PLANNING COMMISSION AGENDA

1. Case 12-1 MFRA, INC. – Site plan approval for a multi-tenant commercial building, 1835 Gateway Drive - Public Hearing

Subject: Case 12-1 MFRA, INC. – Site plan approval for a multi-tenant commercial building, 1835 Gateway Drive - Public Hearing

MFRA is requesting site plan approval to construct a multi-tenant commercial building.

Sheet Title
SITE PLAN

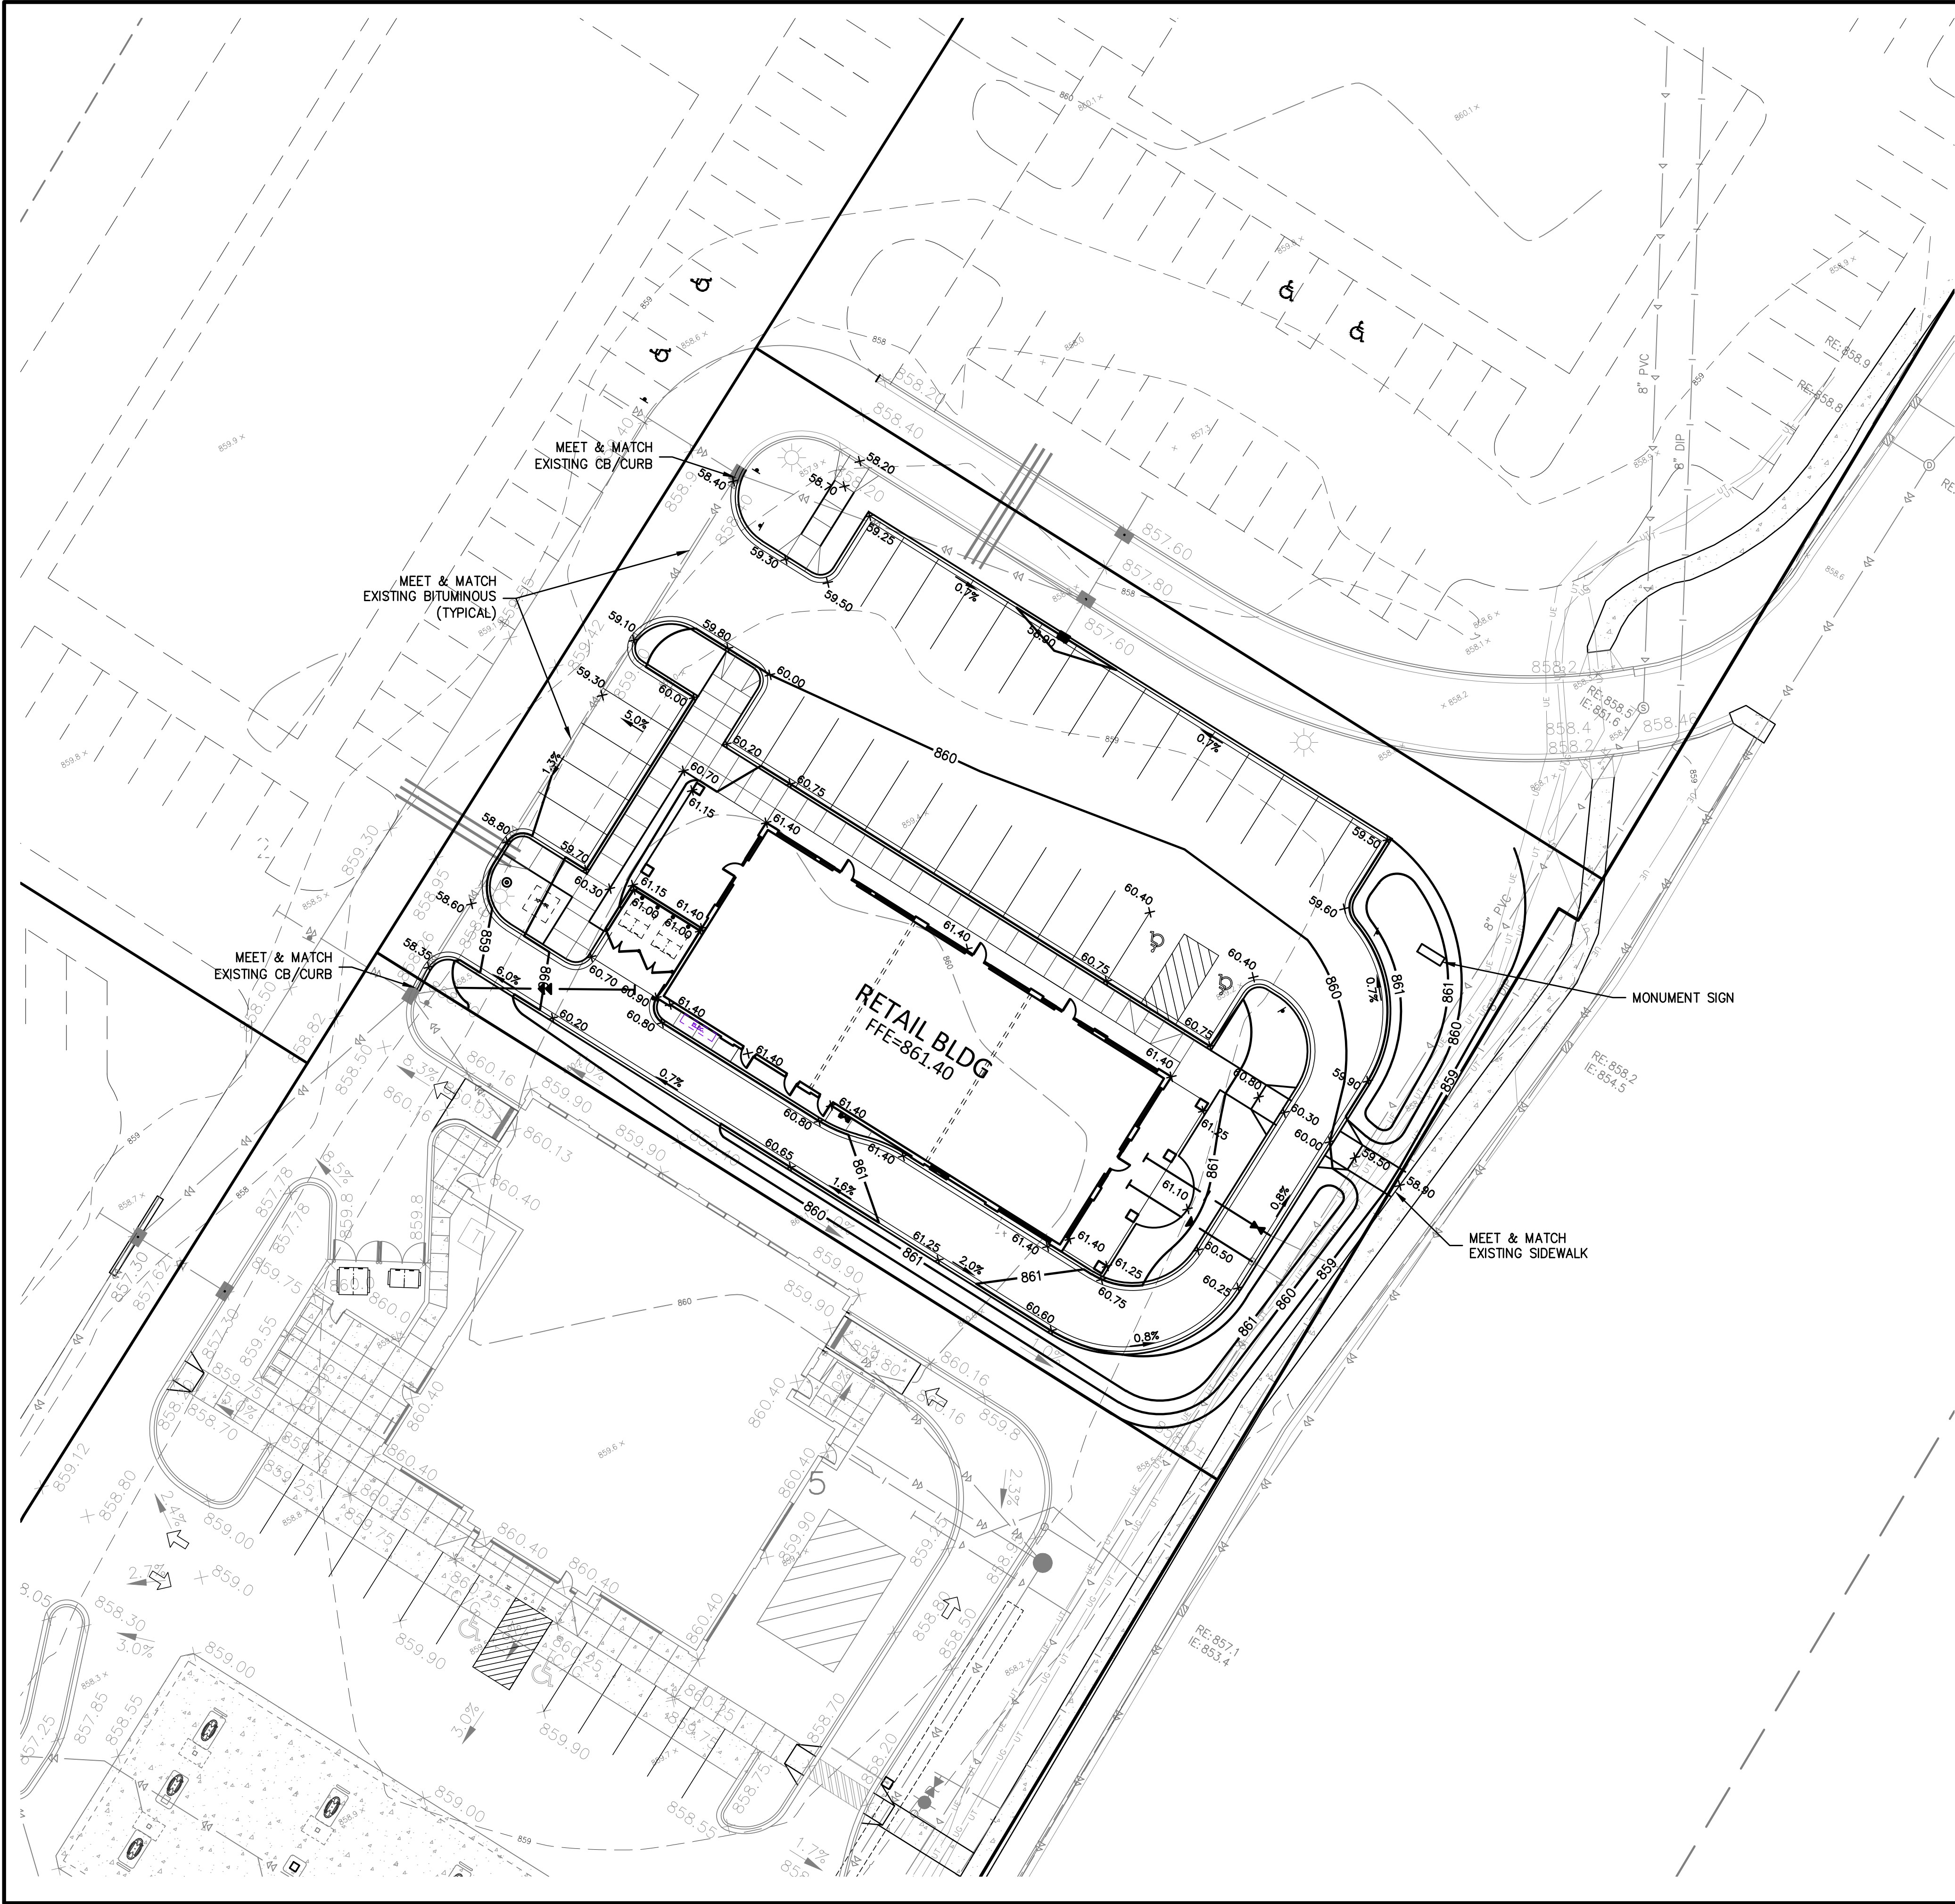
A right-in access from Hanson Boulevard is provided to the north of this site. It is included on the overall PUD site plan. At this point in time it will be a one-way into the site. To ensure that drivers do not mistake it for an exit, signage should be included that identifies the driveway as one-way, do not enter.

Sheet Title
**LANDSCAPE
PLAN**

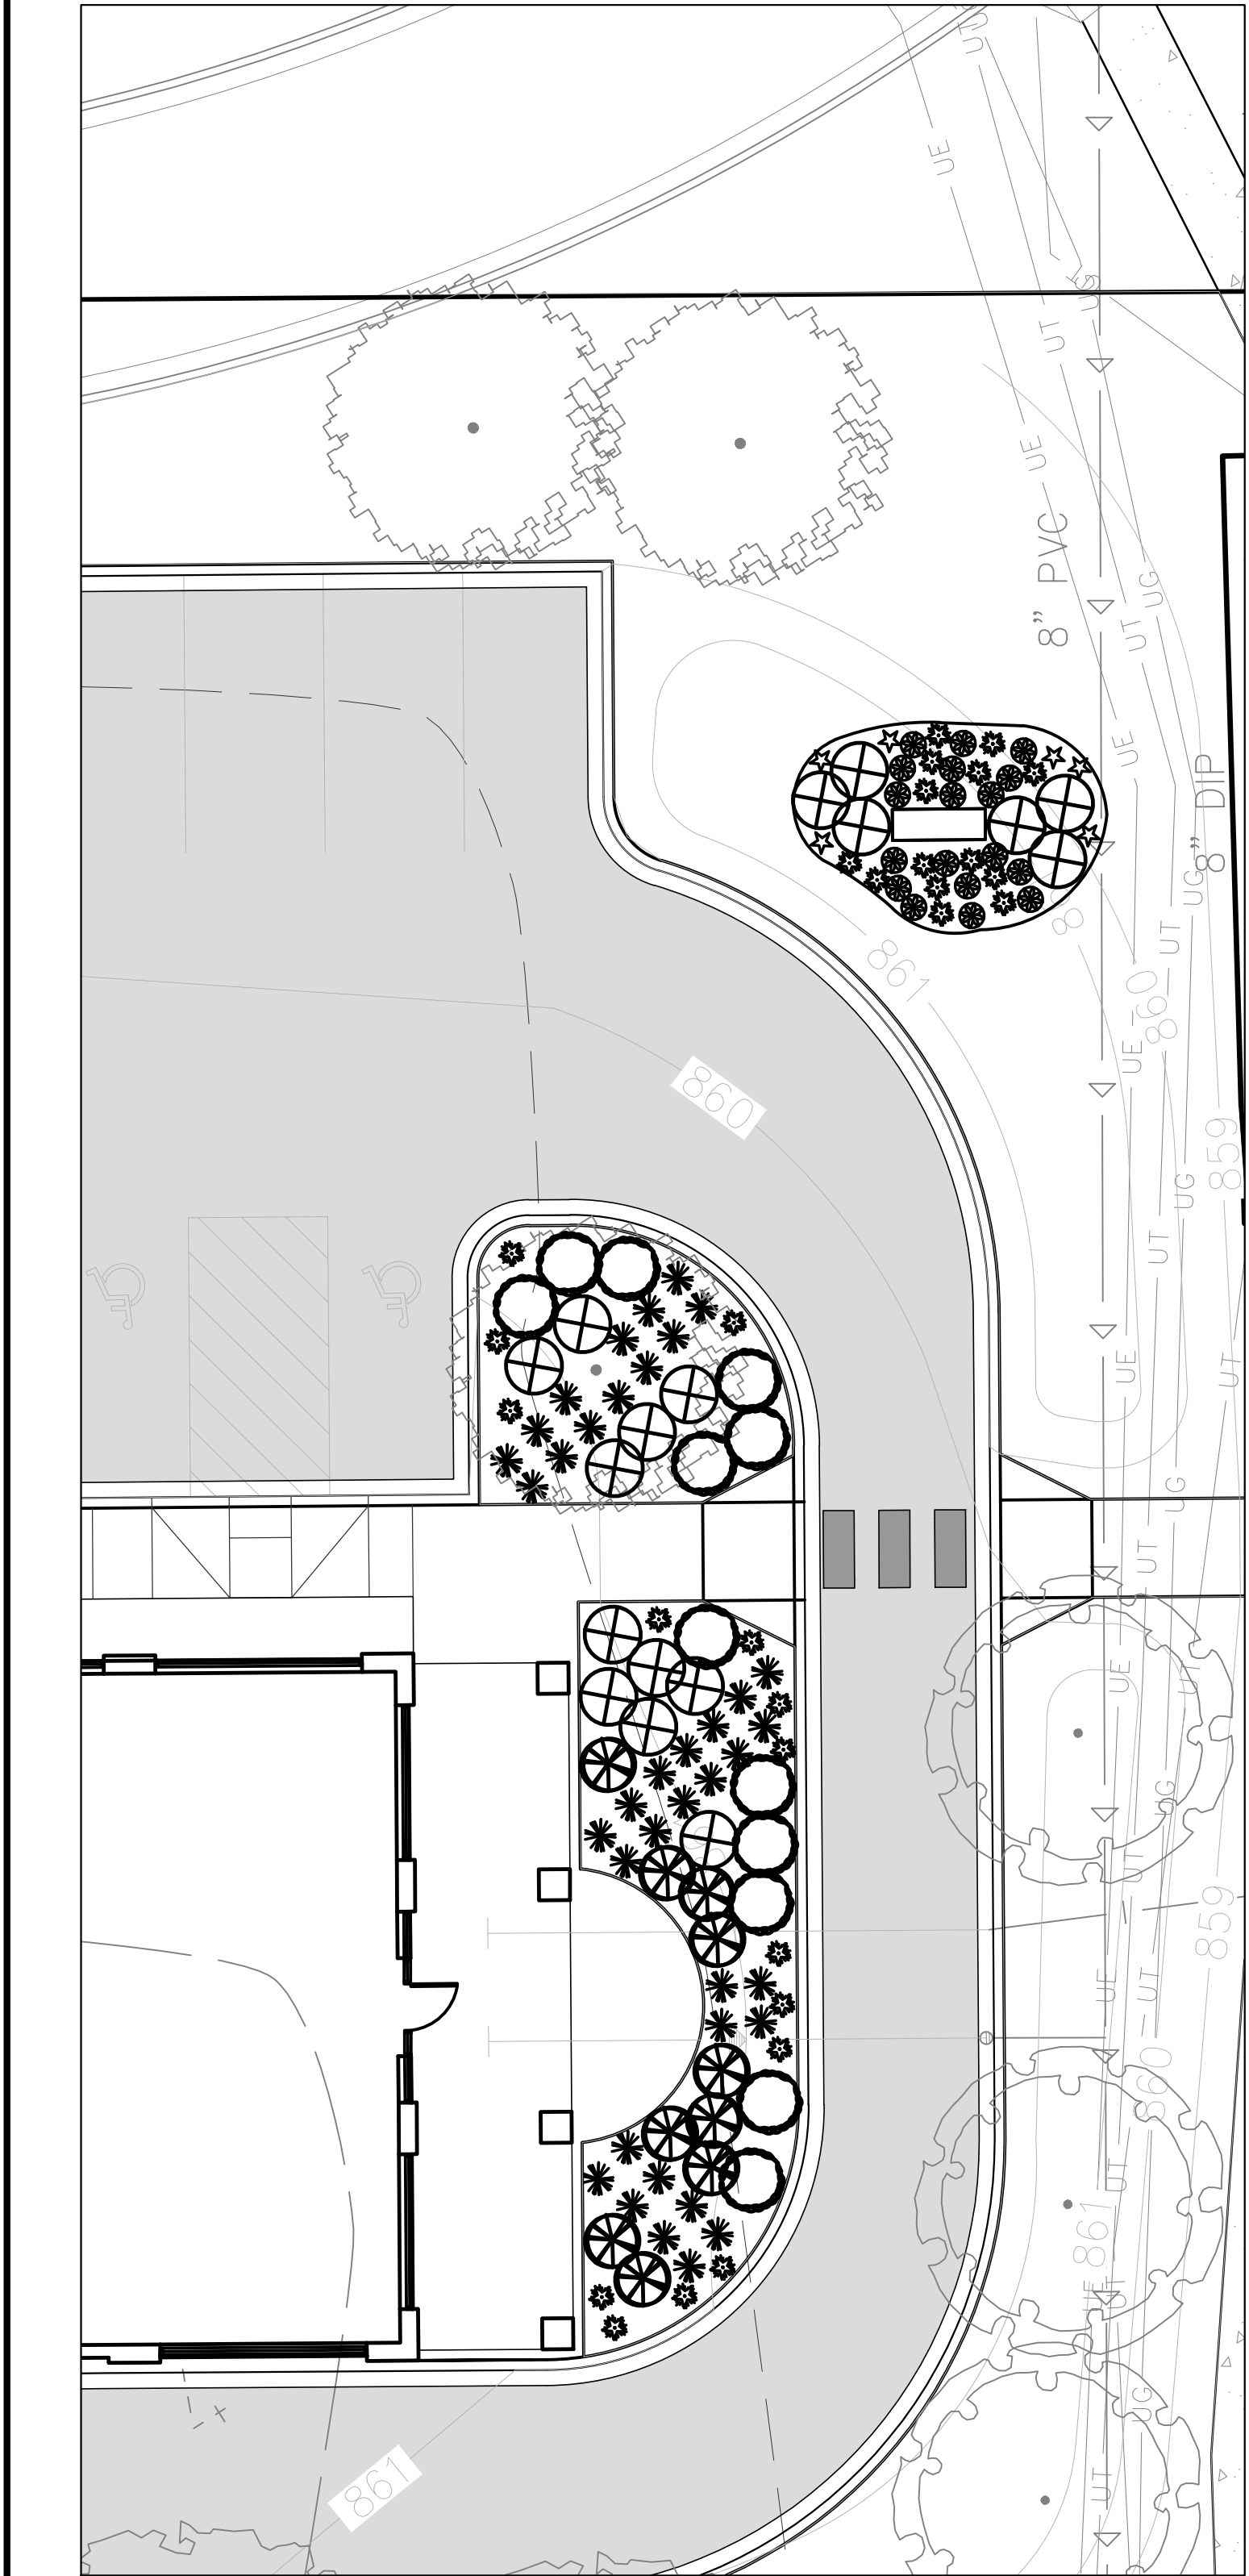
The proposed landscape plan should be amended slightly to comply with the conditions of the PUD site plan approval. The proposed ornamental trees along Hanson Boulevard should be changed to overstory trees and an additional tree should be provided. Staff recommends Autumn Blaze Maples to provide shade during the summer and color in the fall. The landscaping along the interior of the site is consistent with the PUD. To provide a buffer in the area between the paving and Hanson Boulevard, the area should be landscaped with a combination of fencing, walls, berms and plantings.

1. The ornamental trees along Hanson Boulevard must be changed to Autumn Blaze Maples and an additional tree must be provided for a total of four.
2. The area between the paving and Hanson Boulevard must be landscaped with a combination of fencing, walls, berms and plantings.
3. The mechanical equipment must be screened and coordinated with the architecture of the building using the same materials and construction type as the building.
4. Bike racks are required.
5. No outdoor storage or display is permitted.
6. Wall lighting must be prairie style similar to the wall light on the Holiday store.
7. Parking lot lights must match the other lights used in the development.
6. Canopies and awnings cannot be illuminated.
